ENGINE - HIGH PRESSURE TURBINE - PROVIDE NEW STAGE 1 AND 2 HIGH PRESSURE TURBINE DUCT SEGMENTS - CATEGORY CODE 7 - MOD.ENG-72-0310

V2500-ENG-72-0310

Location of the Stage 1 High Pressure Turbine Duct Segments  
Figure 1

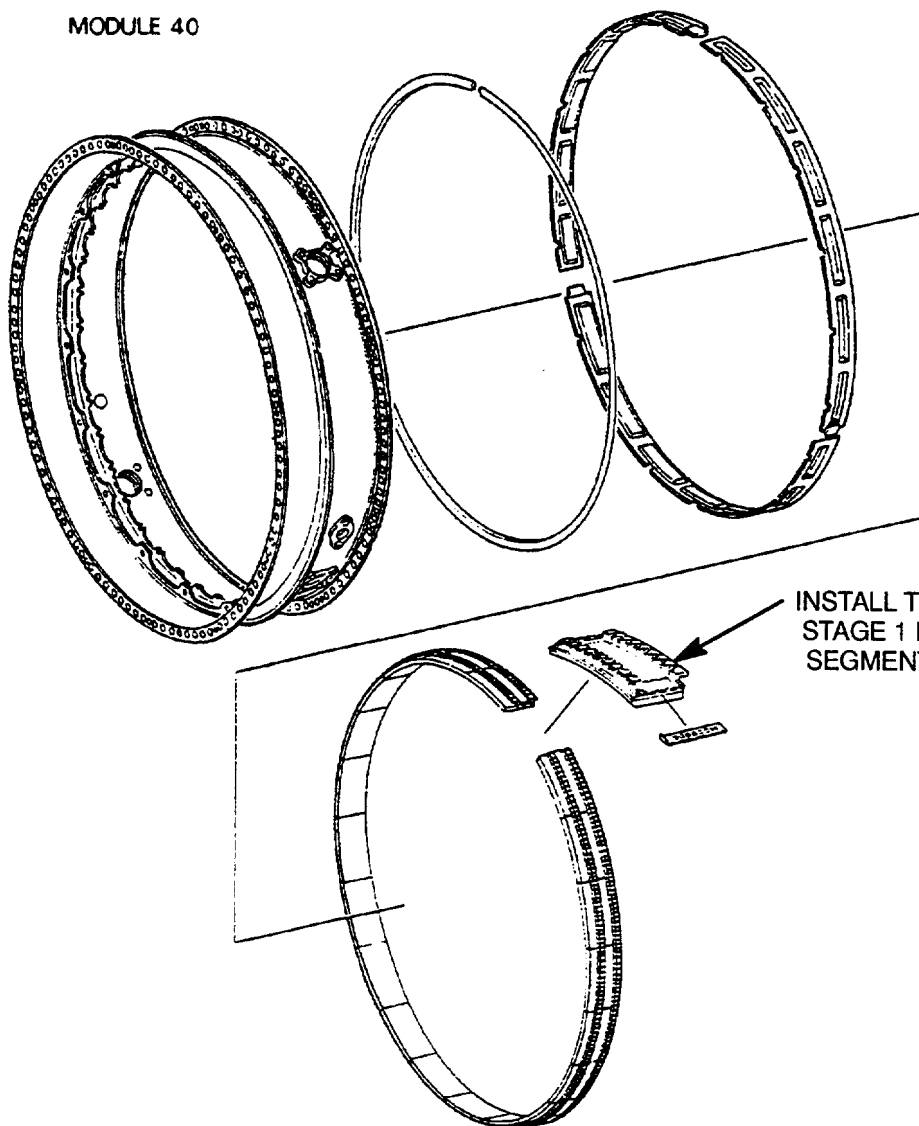
- A. Install the 2A3361 (V2500-A1 Engines only) Stage 1 High Pressure Turbine Duct Segments (19 off) by the procedure specified in Reference (2) or (3), Chapter/Section 72-45-20 Assembly-01. See Figure 1.

- (1) Do not do the grind procedure specified in Reference (2), Chapter/Section 72-45-20, Assembly-01, Config-01, Subtask 72-44-20-440-061-002 for V2500-A1 engines.

NOTE: The new Stage 1 High Pressure Turbine Duct Segments are finish machined at manufacture, eliminating the need to machine (grind) at assembly.

Location of the Stage 2 High Pressure Turbine Duct Segments  
Figure 2

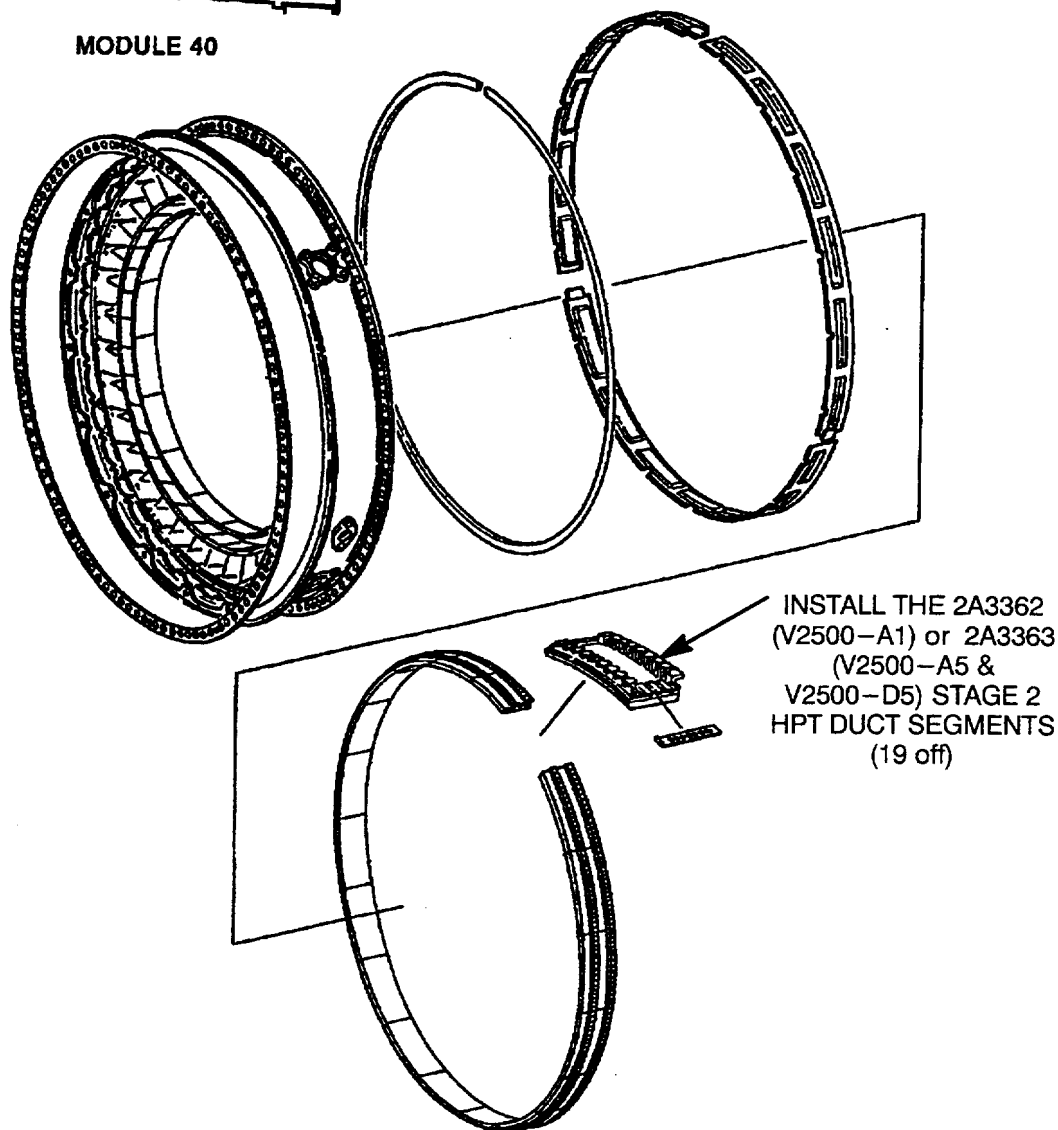
- B. Install the 2A2362 (V2500-A1) or 2A3363 (all except V2500-A1) Stage 2 High Pressure Turbine Duct Segments (19 off) by the procedure specified in Reference (2) or (3), Chapter/Section 72-45-20 Assembly-01. See Figure 2.

- (1) Do not do the grind procedure specified in Reference (2) or (3), Chapter/Section 72-45-20, Assembly-01. See the applicable subtask for the particular engine model.

NOTE: The new Stage 2 High Pressure Turbine Duct Segments are finish machined at manufacture eliminating, the need to machine (grind) at assembly.

Family Tree - High Pressure Turbine Case and Vane Assembly (V2500-A1) Ref. Catalog  
Sequence No. 72-45-20. Fig. 01 Item 005  
Figure 3

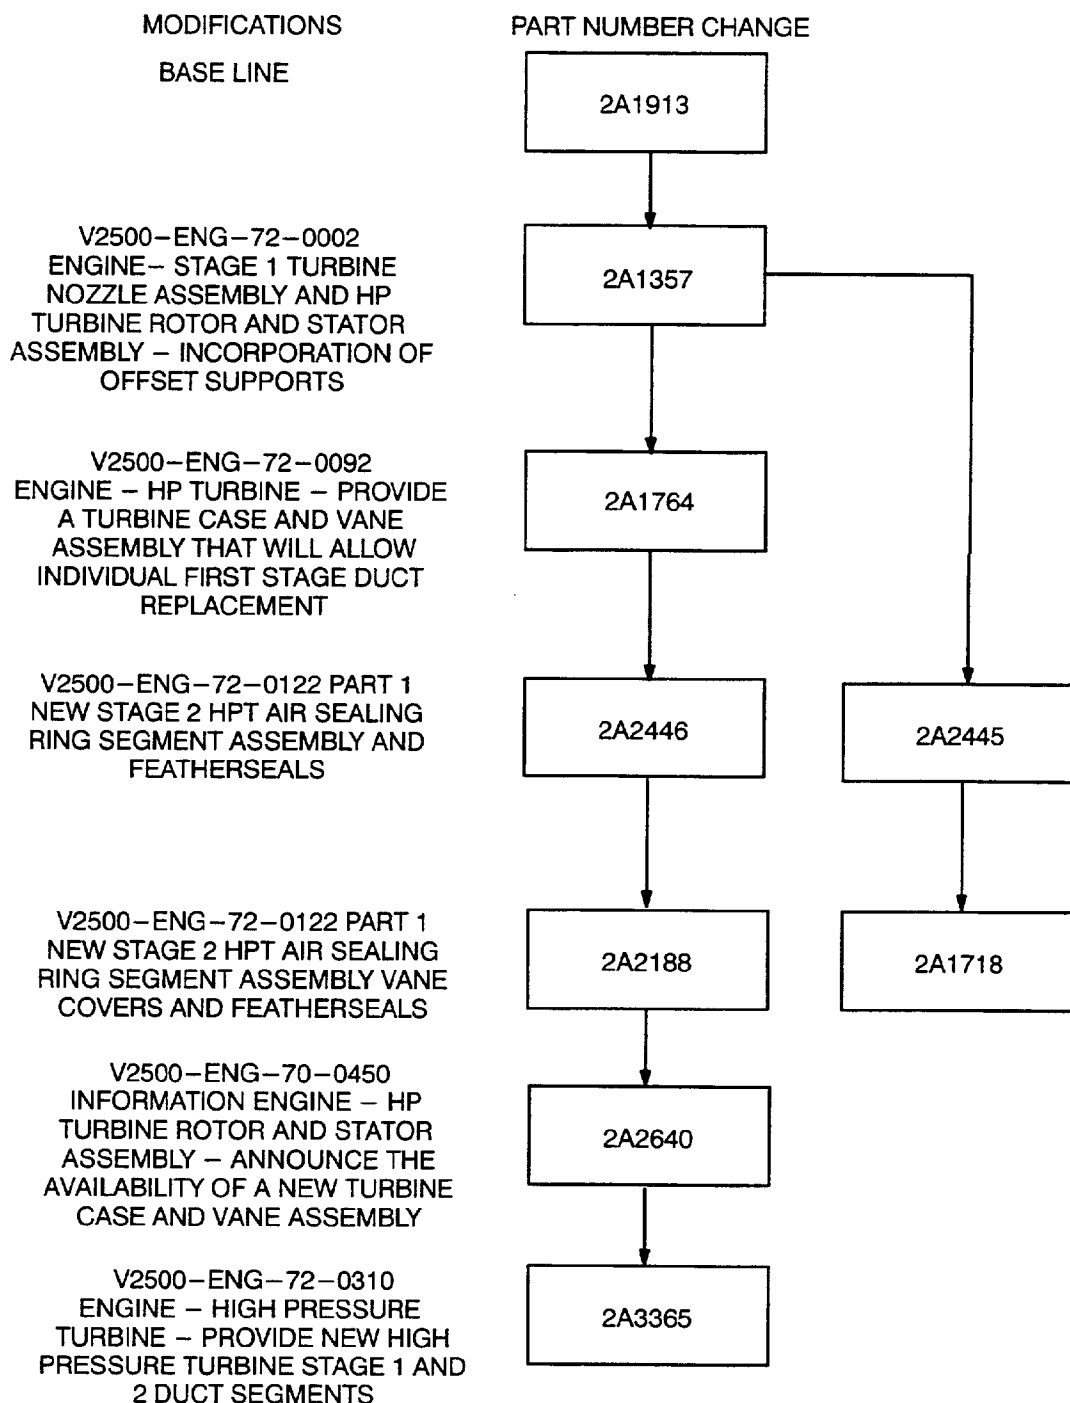
Old Part Number	New Part Number
2A2640	2A3365
2A3219	2A3364
2A3215-001	2A3215-002

Family Tree - Stage 1 High Pressure Turbine Duct Segment Ref. Catalog Sequence No.  
72-45-23. Fig. 01 Item 060  
Figure 5

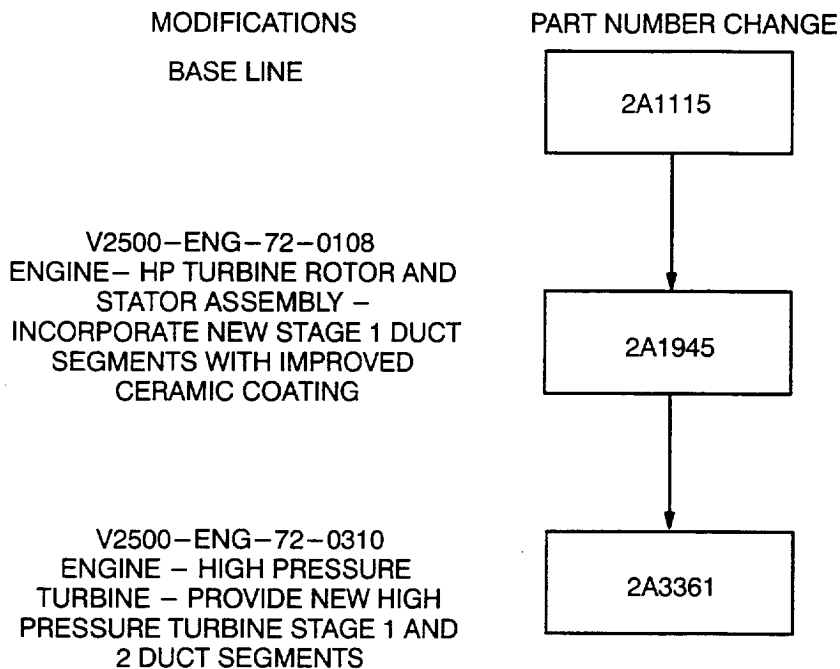
New Part No. (ATA No.)	Qty	Est'd Unit Price (\$)	Keyword	Old Part No. (IPC No.)	Instructions Disposition
-----					
Applicability: For each V2500-A1 Engine to incorporate this Service Bulletin					
2A3365 (72-45-20)	1		Case & Vane Assembly	2A2640 (01-005)	(S1)(B)(C)
2A3361 (72-45-23)	19		Stage 1 HPT Duct Segment	2A1945 (01-060)	(S1)(A)(D)

Family Tree - Stage 2 High Pressure Turbine Duct Segment (V2500-A1) Ref. Catalog  
Sequence No. 72-45-25. Fig. 01 Item 060  
Figure 7

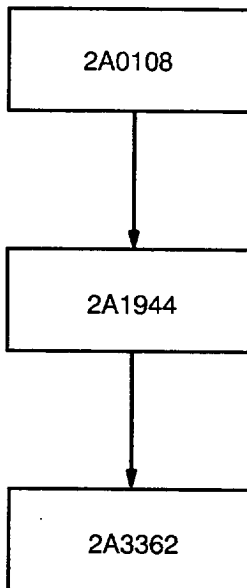
2A3362 (72-45-25)	19		Stage 2 HPT Duct Segment	2A1944 (01-060)	(S1)(A)(D)
----------------------	----	--	-----------------------------	--------------------	------------
